Access Compliance Report

Public Rights-of-Way

Intersection ID: 50241	Main Street: EVERGREEN TERRACE DR	Cross Street: CEDAR WALK LN	Location: SW
ADA ID: 3B1531DE0519	Ramp Type: PerpDiag	Initial Pass/Fail: Fail	Overall Compliance: No
Severity Score: 21.25			
Codes/Mitigation Info/Possible Solution		Field Measurements/Component Compliance

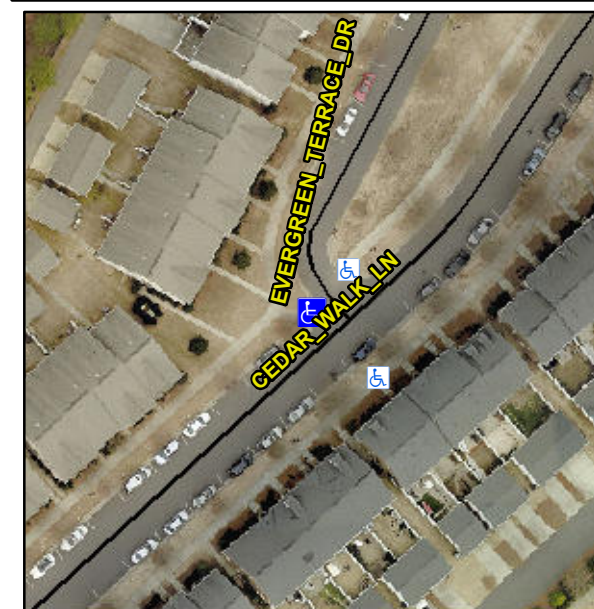
Compliance	Description	Data	Compliance	Description	Data
N/A	Ramp Length (in)	68.5	No	Ramp Slope (%)	11.9
No	Ramp Width (in)	47.5	Yes	Ramp XSlope (%)	1.6
N/A	Flare Type LT	N/A	N/A	Flare Type RT	N/A
N/A	Flare Slope LT (%)	N/A	N/A	Flare Slope RT (%)	N/A
N/A	Flare Traversable LT?	N/A	N/A	Flare Traversable RT?	N/A
N/A	Landing Length (in)	N/A	N/A	DWS Provided?	N/A
N/A	Landing Width (in)	N/A	N/A	DWS Contrast?	N/A
N/A	Landing Slope (%)	N/A	N/A	DWS Length (in)	N/A
N/A	Landing X Slope (%)	N/A	N/A	DWS Full Width?	N/A
N/A	Landing Curb? (Y/N)	N/A	N/A	DWS Offset (in)	N/A
N/A	Shared Landing?	N/A			
N/A	Gutter Ponding?	N/A	N/A	Gutter Slope (%)	N/A
N/A	Gutter Lip Ht (in)	N/A	N/A	Gutter X Slope (%)	N/A
N/A	Painted X Walk1?	No	N/A	Painted X Walk2?	No
	X Walk 1 Direction	To SE		X Walk 2 Direction	To NE
N/A	X Walk 1 Width (in)	N/A	N/A	X Walk 2 Width (in)	N/A
	X Walk 1 Slope (%)	2.7		X Walk 2 Slope (%)	3.7
	X Walk 1 X Slope (%)	2.4		X Walk 2 X Slope (%)	0.7

Remove & Replace Curb Ramp With Two New Directional Ramps or Equivalent.
